DOC18/893817
SSD 9273

**Notice of Exhibition - Redevelopment of Wentworthville Public School, 70-100 Fullagar Road,
Wentworthville - SSD 9273**

Attachment 1 – OEH comments - Exhibition of Wentworthville Public School Redevelopment, 70-100 Fullagar Road, Wentworthville - SSD 9273

Image 8: Good canopy of trees near corner of Fullagar and Station Street

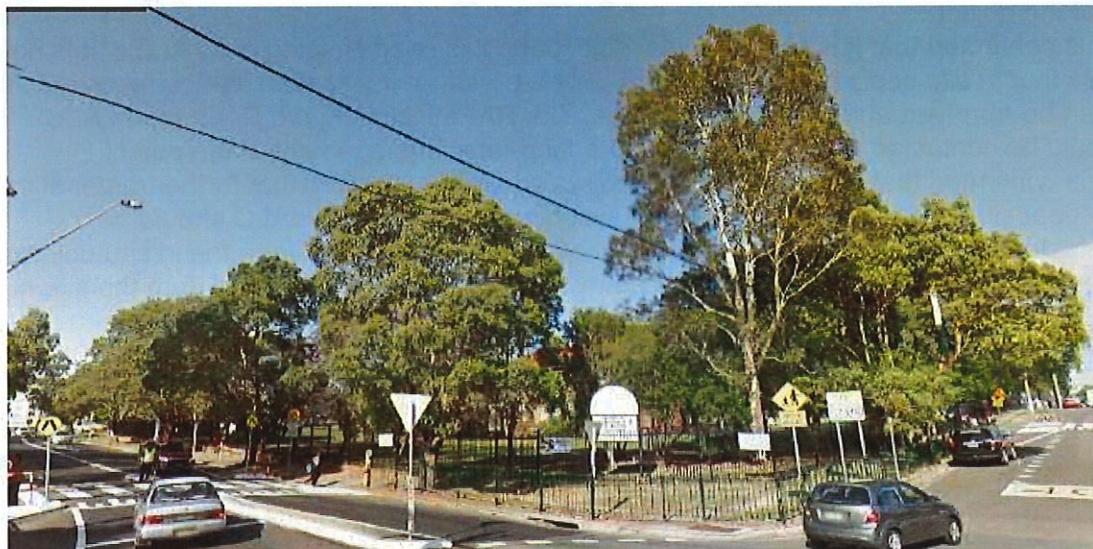
The proposed building footprint of Block G along both Station Street and Fullagar Road impacts on the existing mature trees. Many of the trees proposed for removal are established trees in fair to good condition, see Arborist report photos shown below. A reasonable setback and amended building footprint could ensure their retention particularly Trees 50-55, 57 and 59 along the Fullagar Road site perimeter that should be considered for retention.

- what canopy cover percentage is achieved on site and how it is consistent with this target. OEH recommends existing canopy trees be retained as this will improve amenity and contribute towards meeting this target.
